# 1014 — Space For Ideas

## Community board 8 hearing

Certificate of Appropriateness Application  
no. #M00746664-I1

# **Proposed amendments to approved design**

# Front area — proposed amendments to approved design

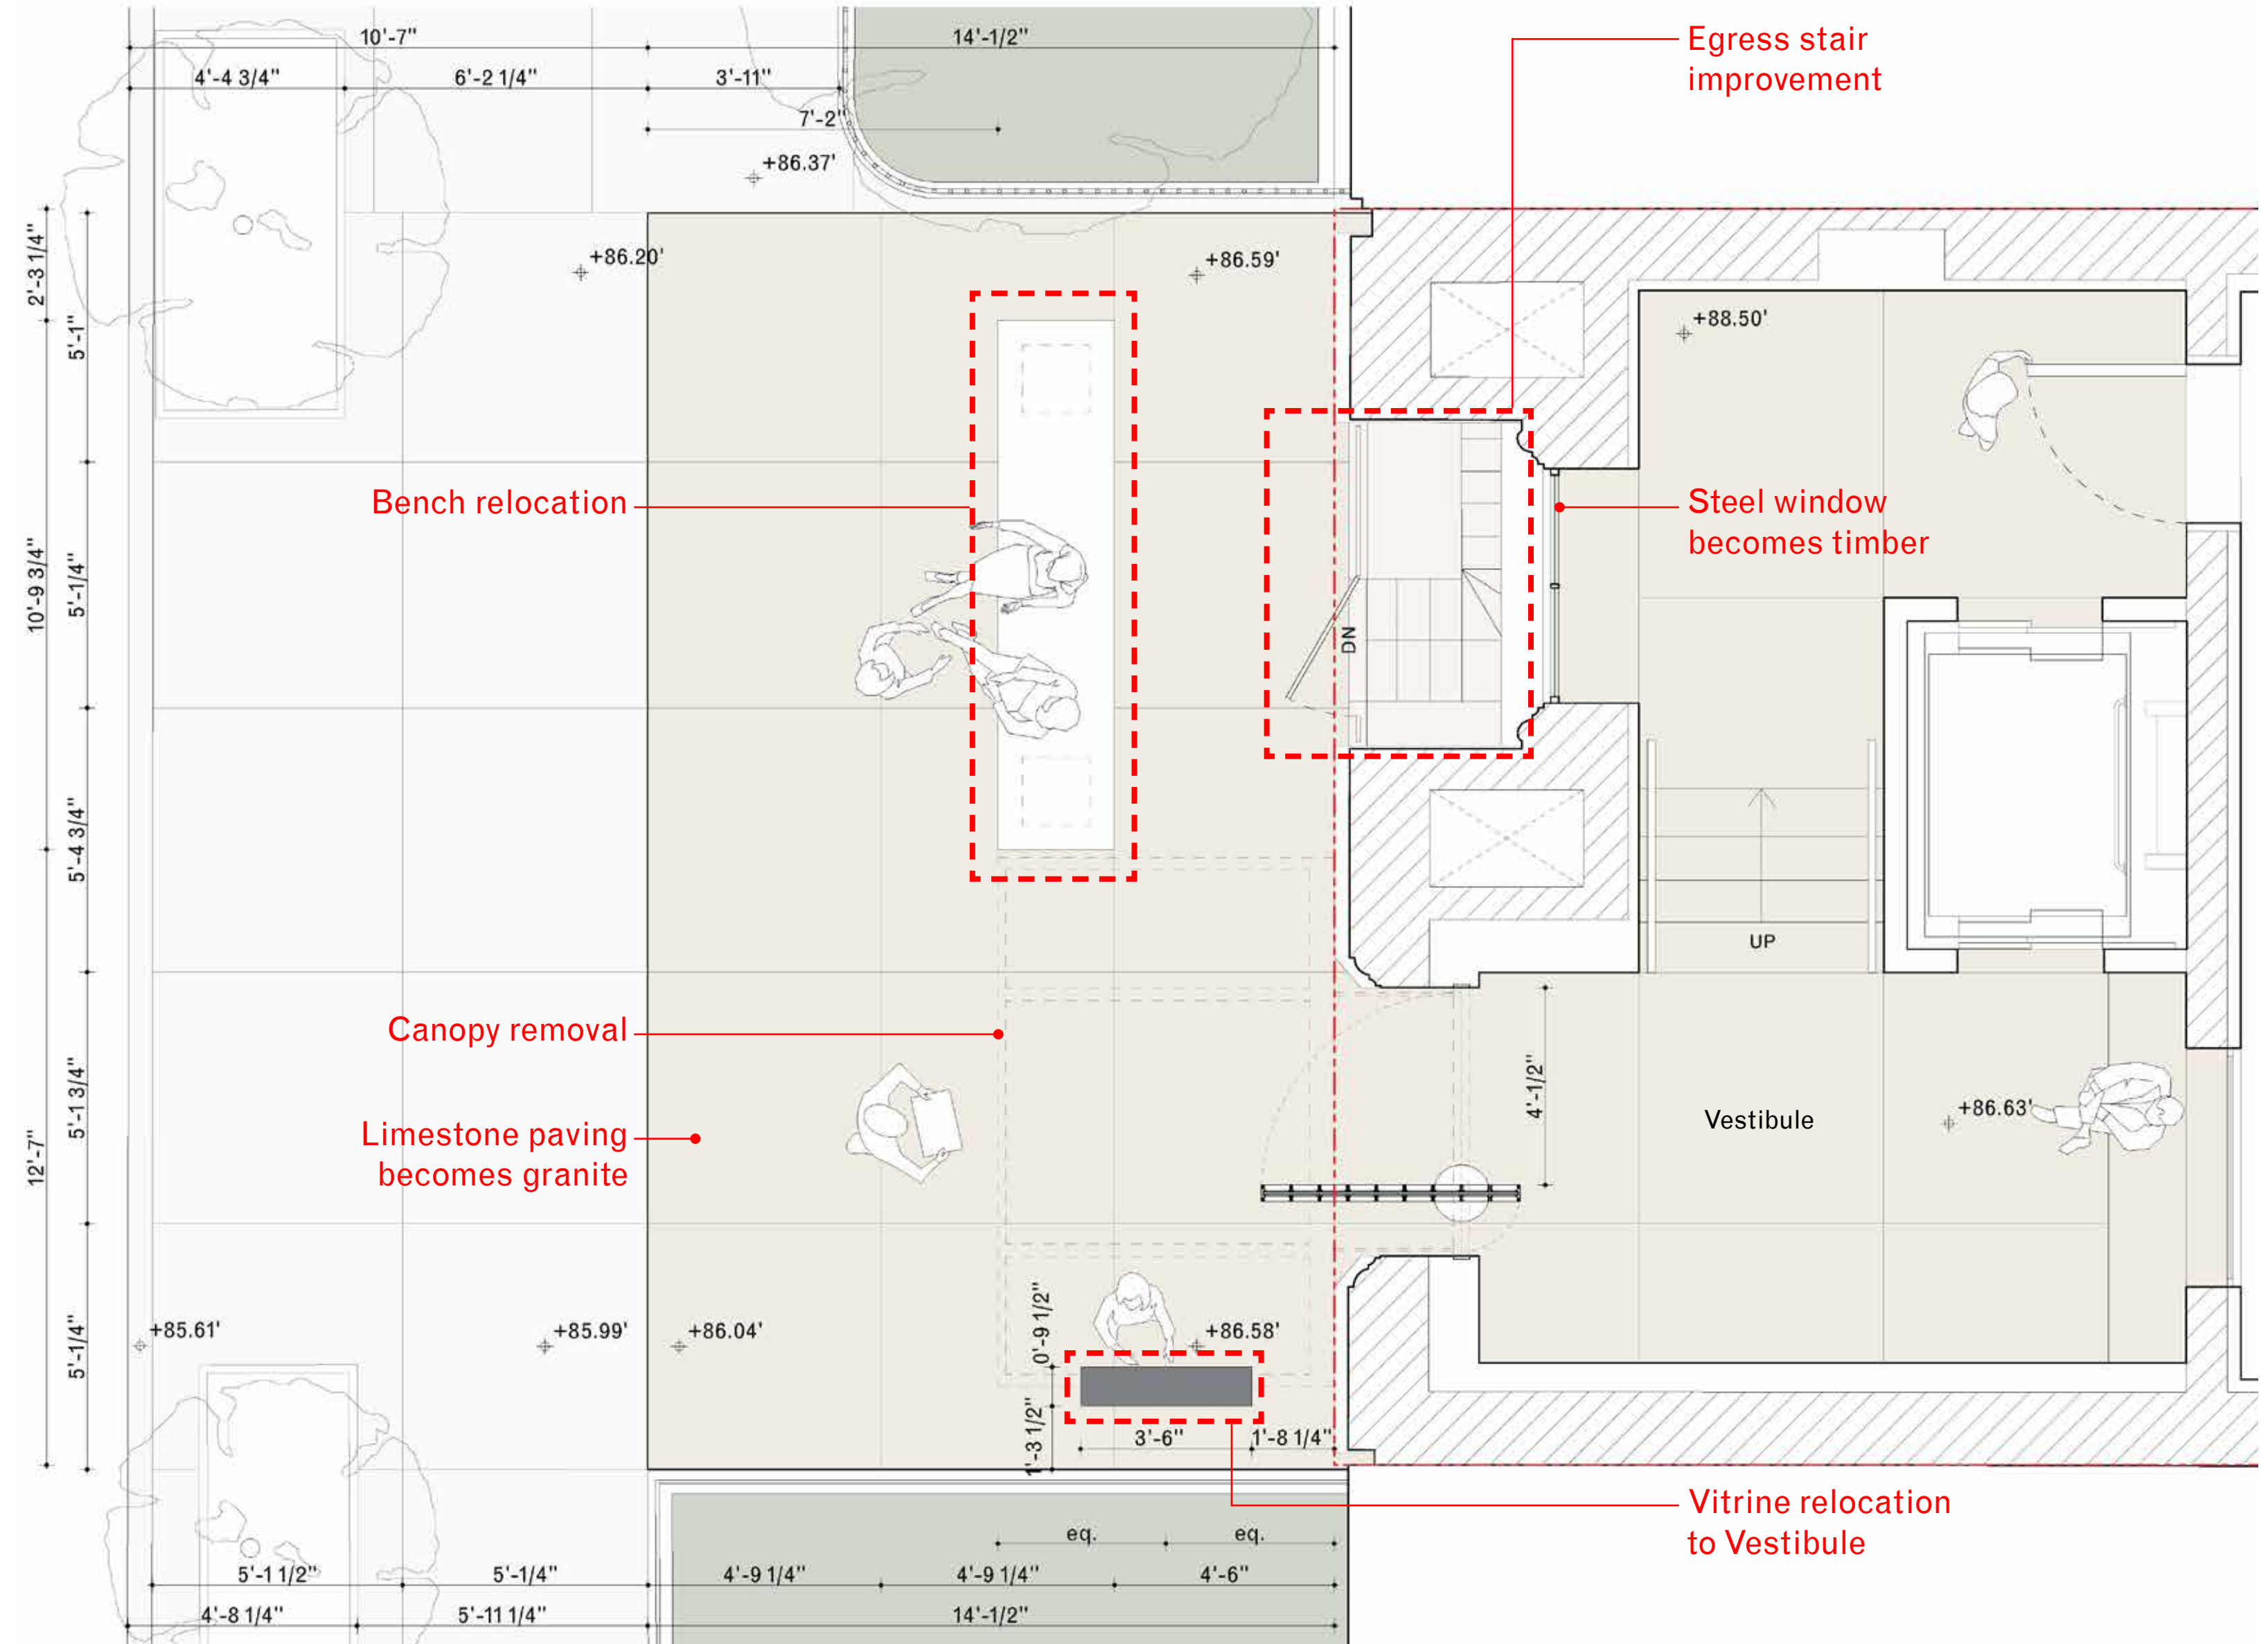
Limestone paving  
becomes granite

Bench  
relocation

Steel window  
becomes timber

Egress stair  
improvement

Canopy removal

Vitrine relocation

# Front area — proposed

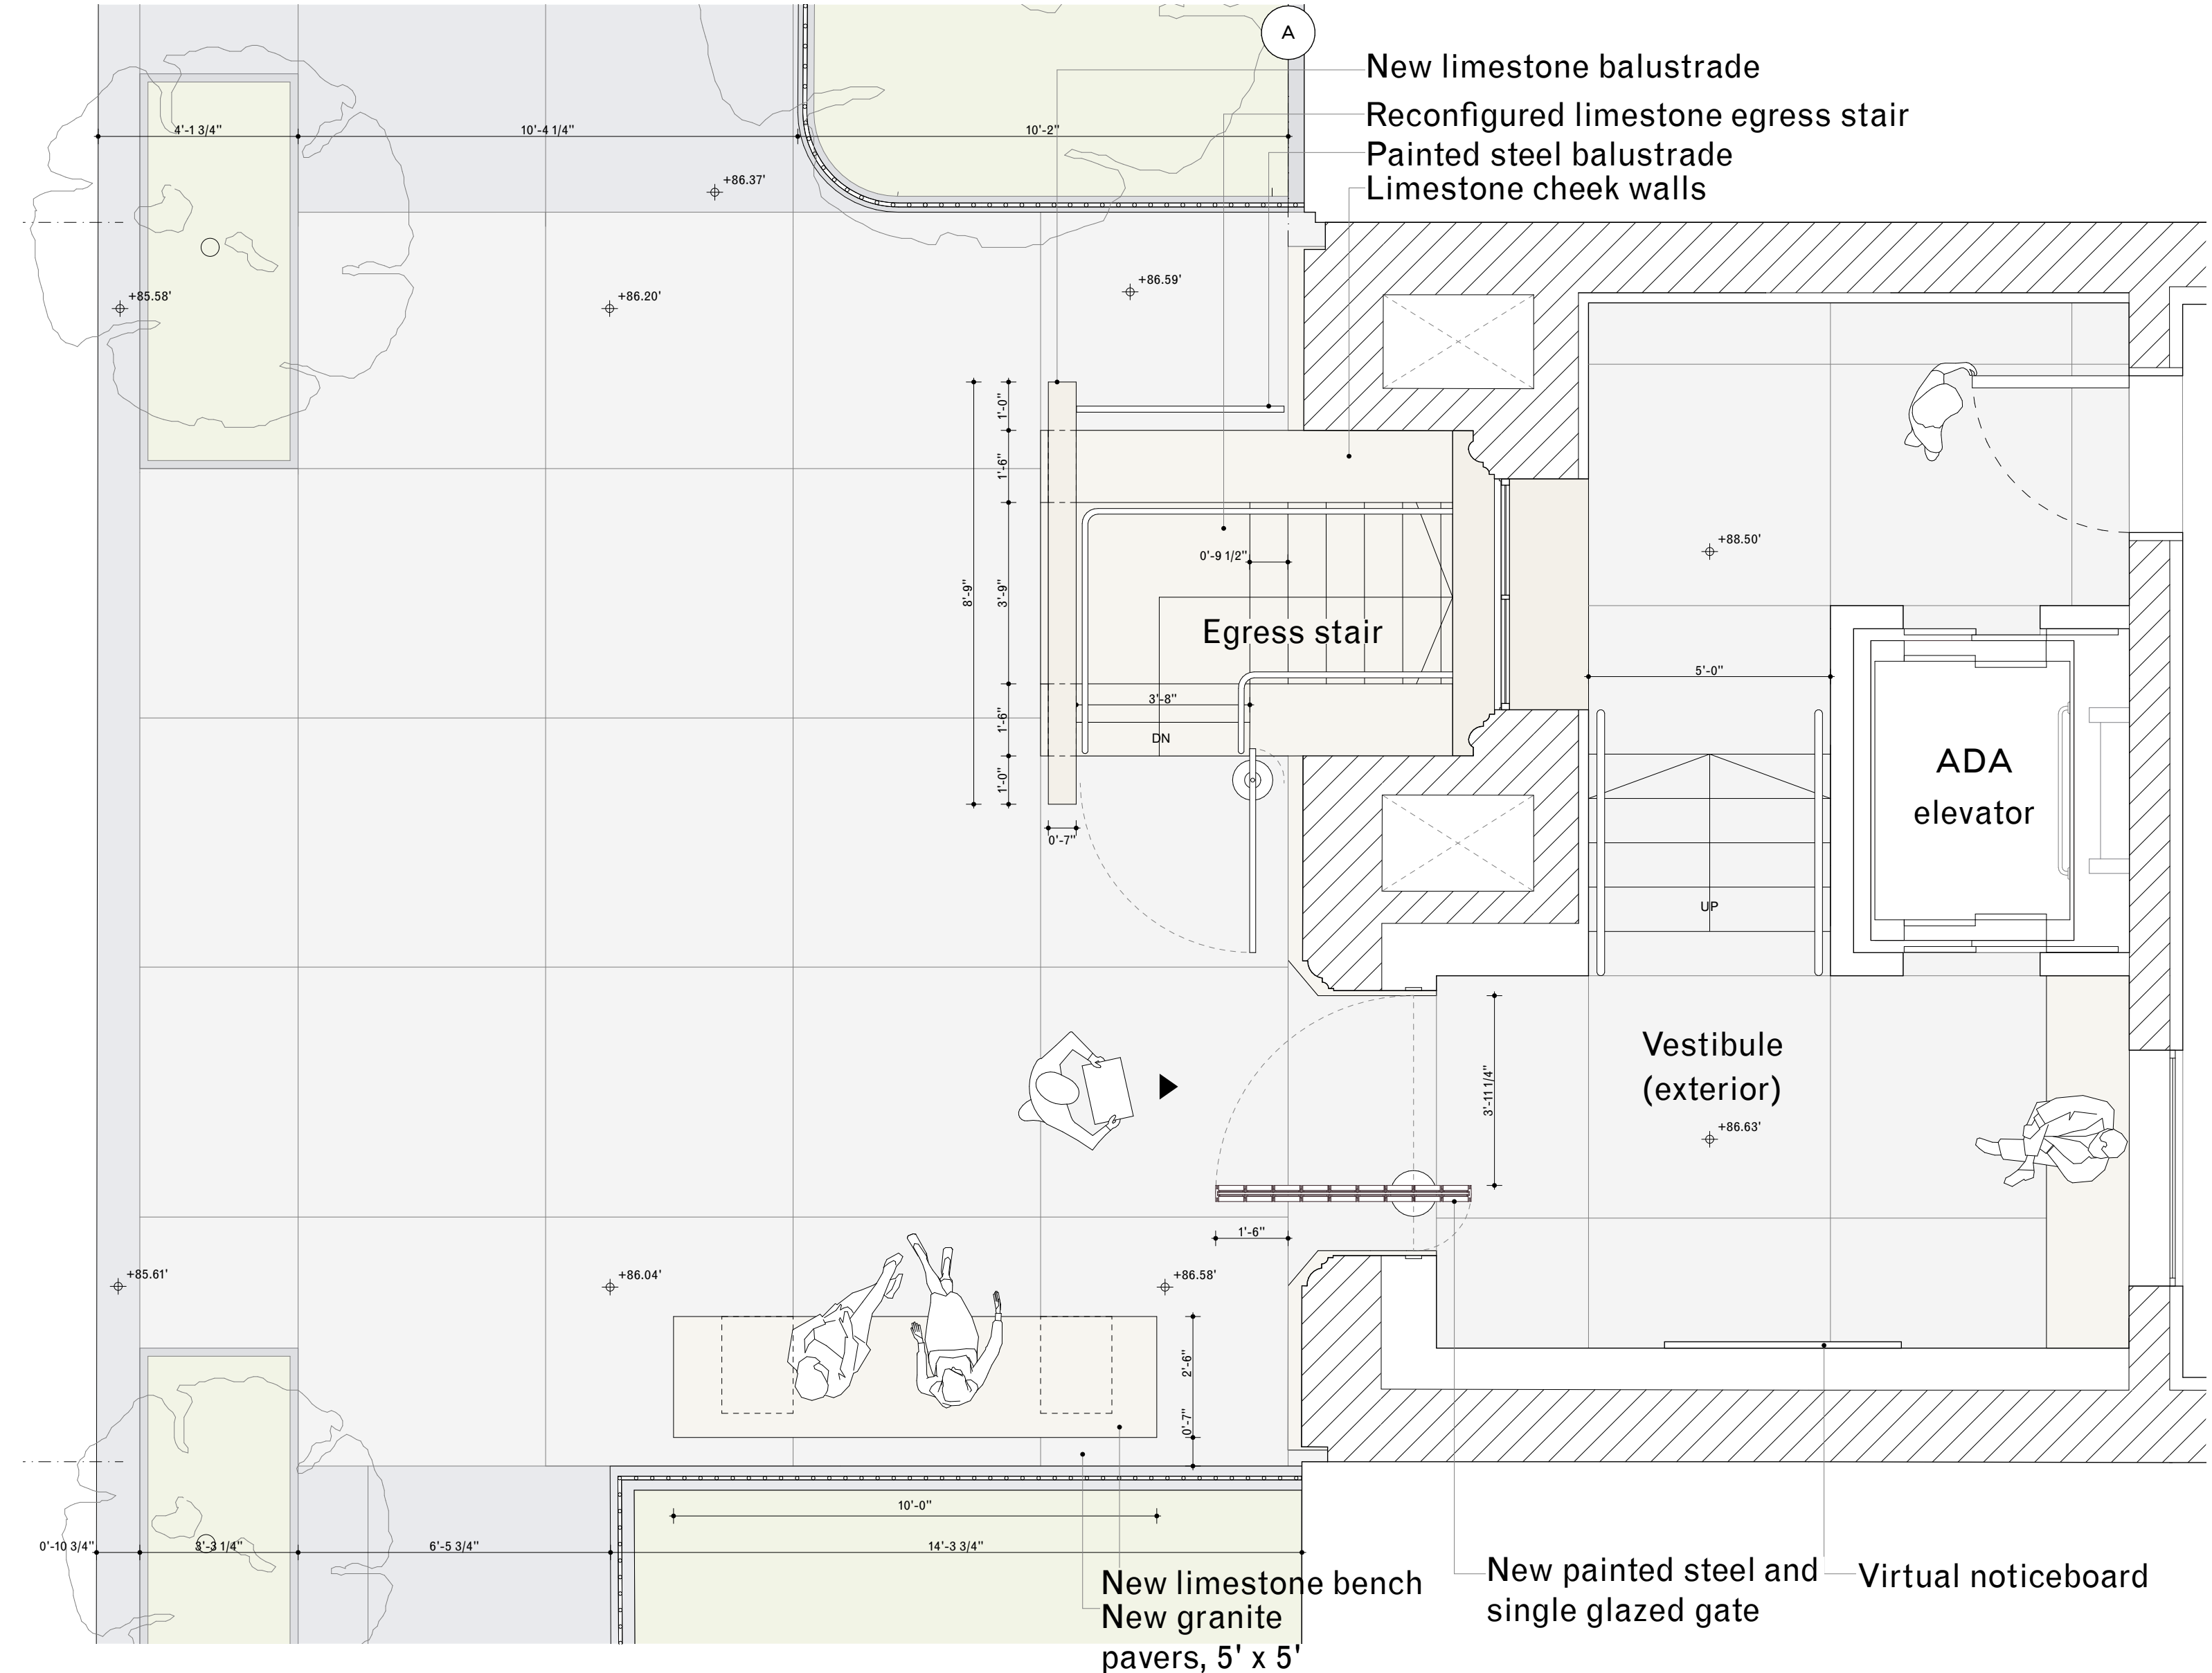
- Egress stair improved, centered on window above and new basement opening utilises existing window lintel
- 5' x 5' granite paving introduced instead of limestone, as more hard-wearing, long-lasting and sourced on East Coast
- Bench is relocated to accommodate stair reconfiguration
- Vitrine is removed, as virtual noticeboard located inside vestibule

# Elevation — gate open

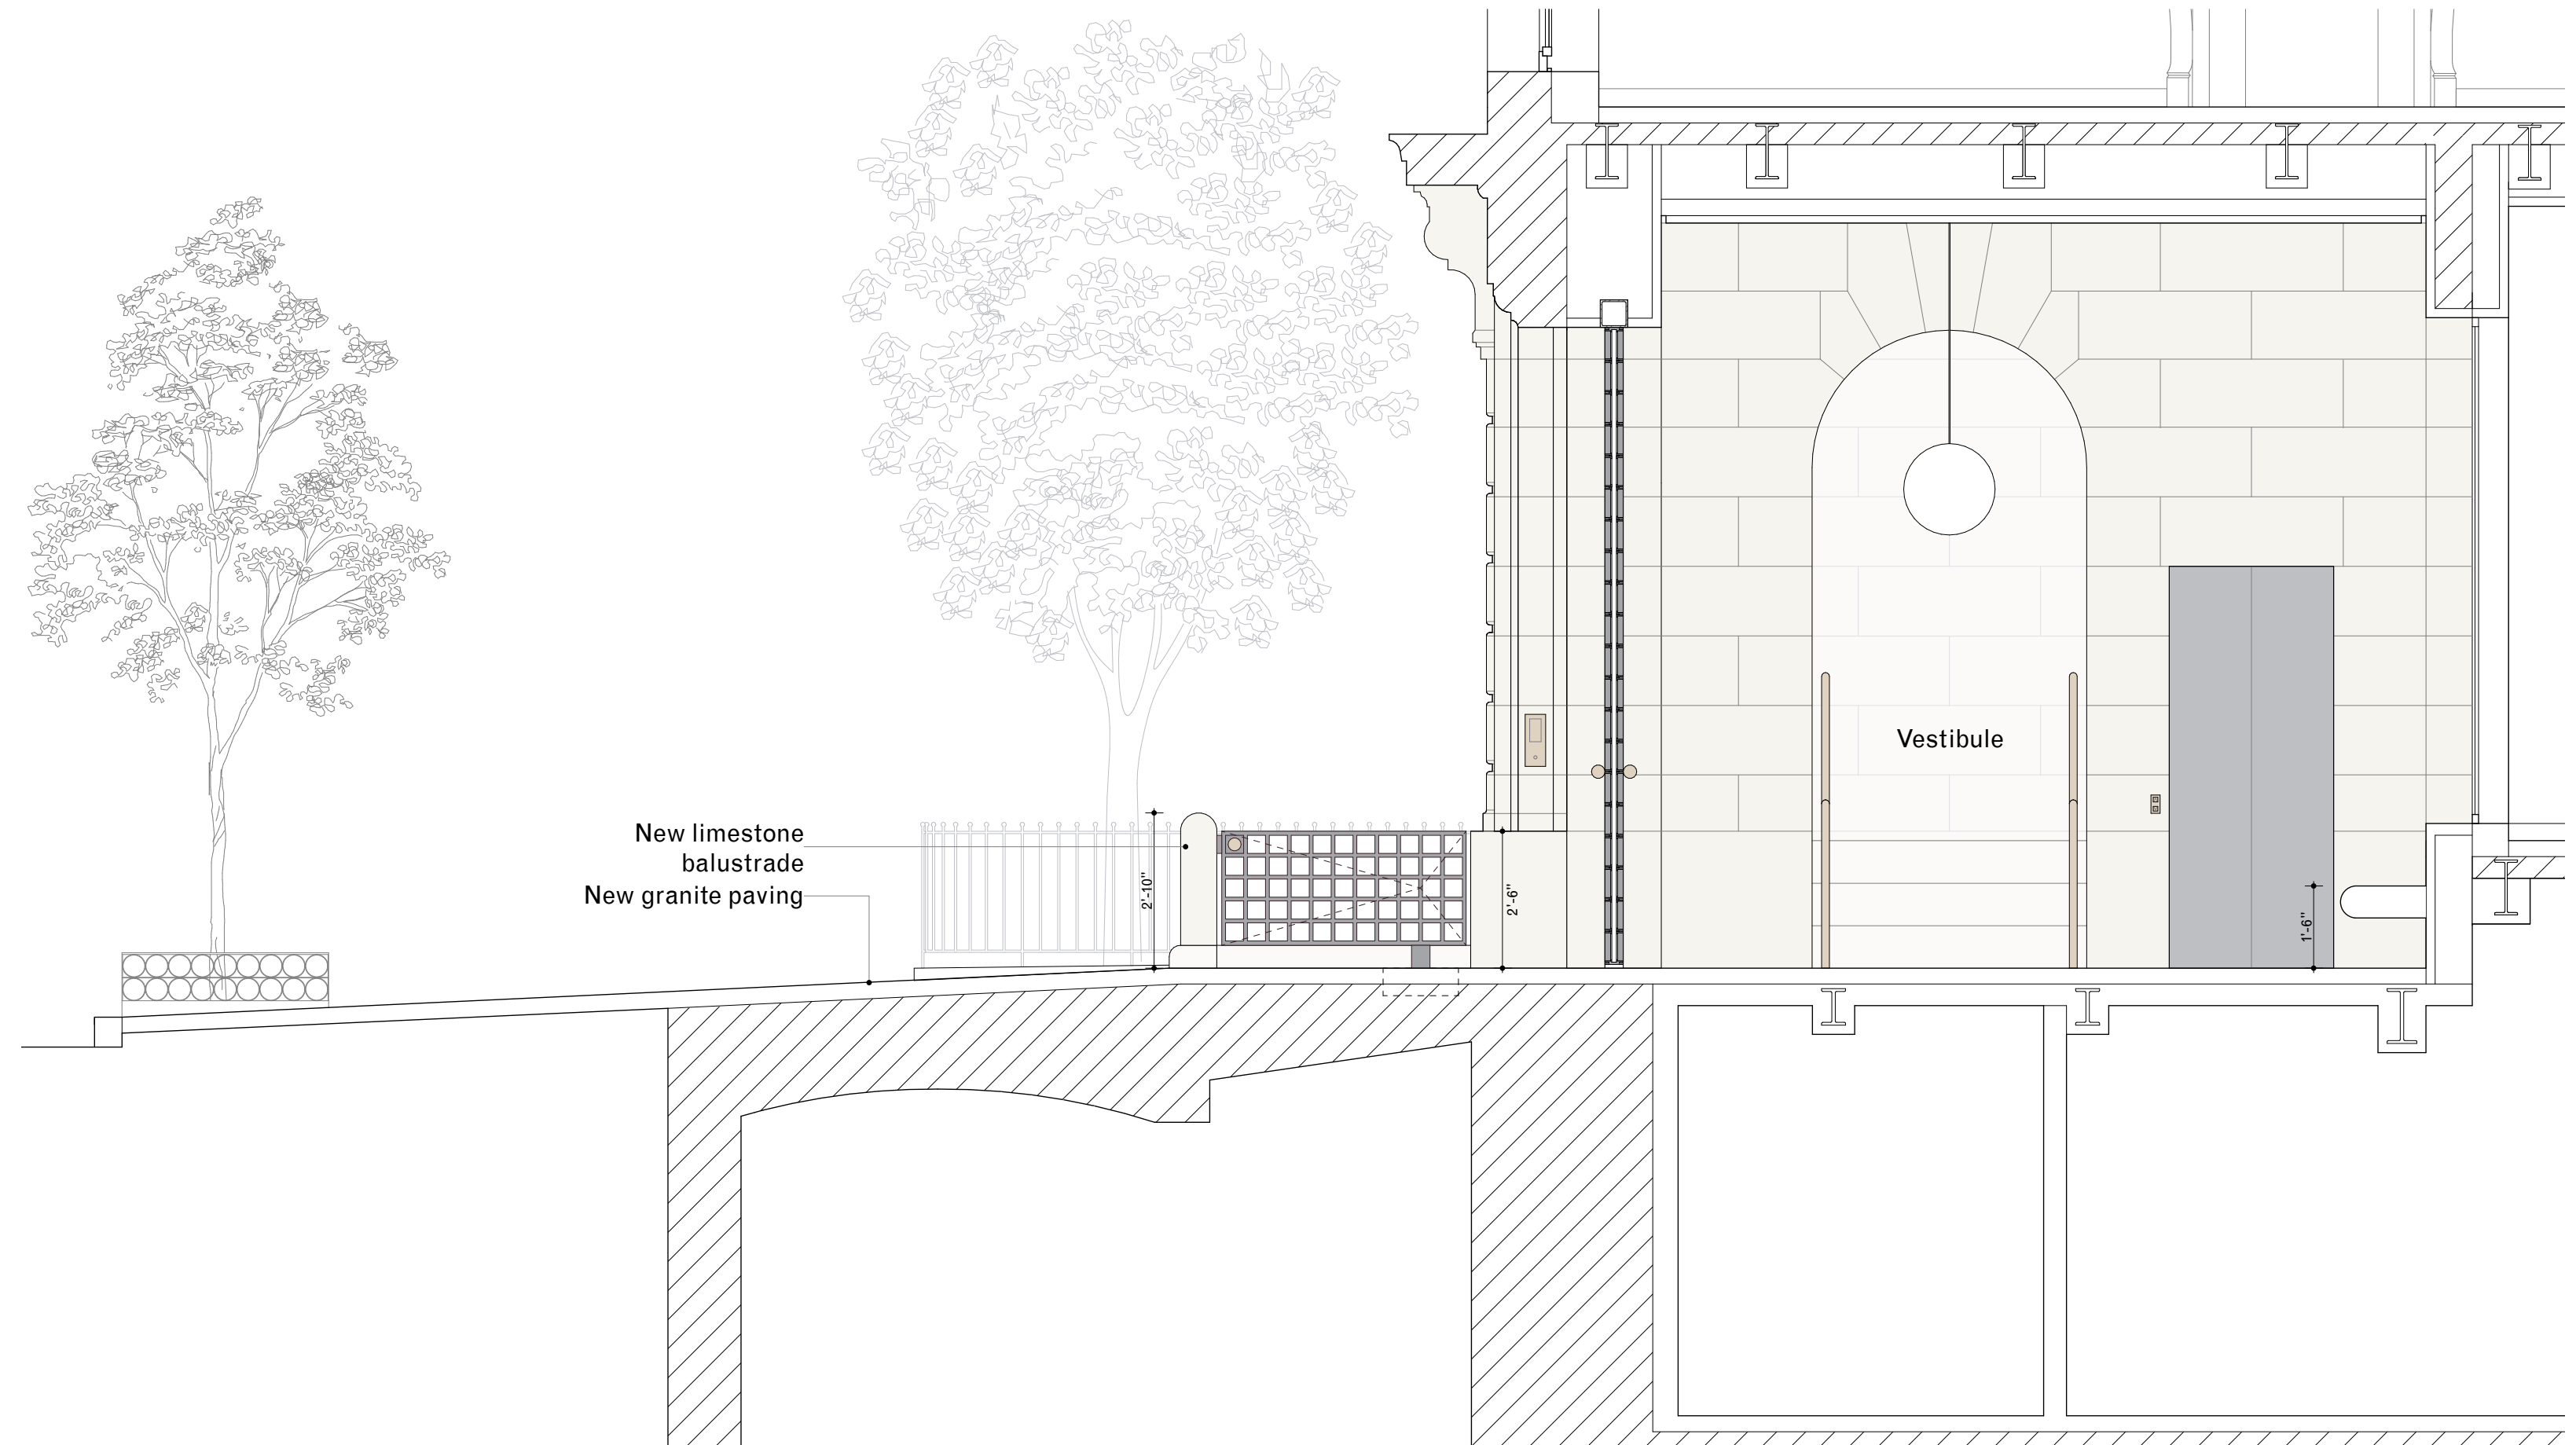
- Canopy removed, following LPC condition to shorten width, shorter width compromised canopy presence and vestibule is already a covered space
- Steel window changed to painted timber window to match previous window, following LPC condition
- Entrance gate is made full-height, changing from a domestic scale to cultural scale
- Address signage plaque added in location of previous signage plaque

Gate would be held open during the day  
and closed at night
